Process Change Notification

Date: October 5, 2012
PCN Reference: M-11-0002
PCR Reference: M-11-0002
Product Reference: D2-Pak HEXFET & IGBT, and D-Pak IPS & HEXFET products

Alternate manufacturing process steps for assembly of D2-PAK HEXFET & IGBT and D-Pak IPS & HEXFET products.

Product Appearance Differences:

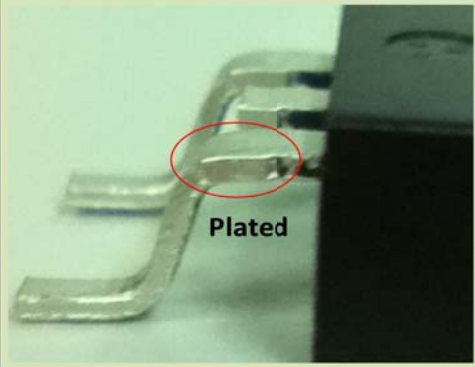
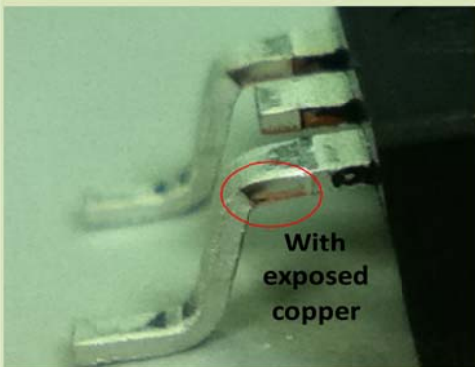
Current Process flow	Propose Process Flow	Differences
 <p>Plated</p>	 <p>With exposed copper</p>	<p>Exposed copper after dambar cut on Trim/Form/Singulation Integration. This condition is similar on lead cut and heatsink cut on the current process flow.</p>
